**ADDENDUM TO FACT SHEET  
PORT OF SEATTLE  
SEA-TAC INTERNATIONAL AIRPORT  
Modification of NPDES Permit Number WA-002465-1  
in Compliance with Requirements of the  
Pollution Control Hearings Board**

**SUMMARY**

Figure 2: Delineated wetlands, and monitoring sites on north side of Airport, Miller Creek basin. (Source: Port of Seattle).

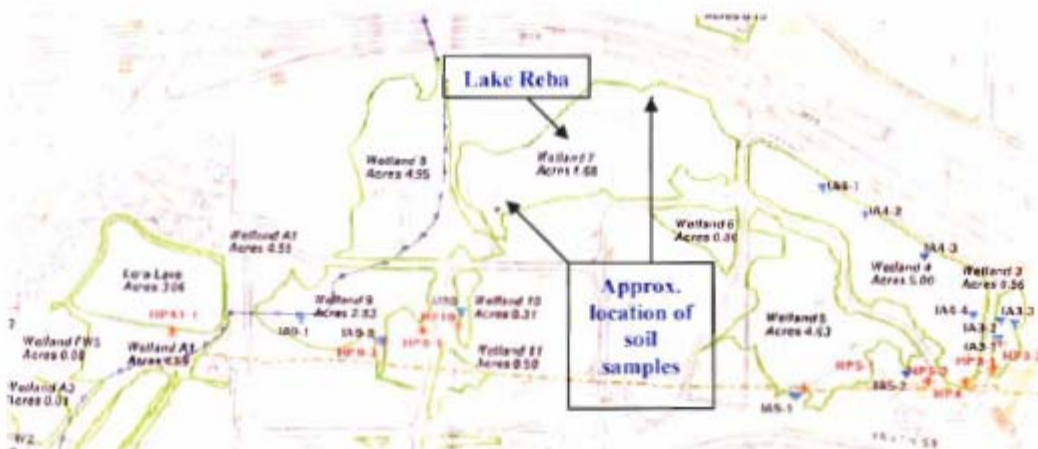
10. The 2001 Natural Resource Mitigation Plan prepared by Parametrix for the Third Runway project at SeaTac delineated and mapped the Lake Reba wetlands complex as a biological wetland.<sup>2</sup> The wetland complex includes wetlands mapped as number 3, 4, 5, 6, and 7 in figure 1 (above) and figure 2 (below). Wetland 7, including the excavated "lake", is 6.68 acres in size. The wetland complex totals 17.73 acres upgradient of the outlet structure.

Figure 3: Miller Creek peat area (from Rigg 1958, page 78)

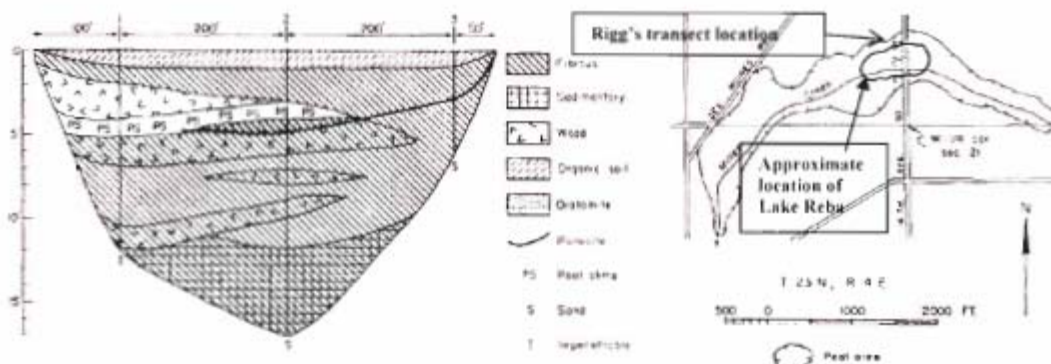
19. The Lake Reba wetland complex is part of the 56-acre peat wetland mapped as the "Miller Creek peat area" by Dr. George Rigg in his 1958 document titled "Peat Resources of Washington." Lora Lake, Vacca Farm, and the King County Miller Creek regional detention facility are also part of Miller Creek peat area. Rigg cored the peat in three locations along a transect just west of (former) 16<sup>th</sup> Ave South. He found the peat to occur up to seventeen feet deep, overlaying sand. The peat profile is shown below in figure 3 (below). You will notice the interbedded nature of the various types of organic soil in the profile. You will also note that 16<sup>th</sup> Avenue South was vacated and removed (presumably) when State Route 518 was constructed. The eastern boundary of Lake Reba straddled the right of way of 16<sup>th</sup> Avenue South.
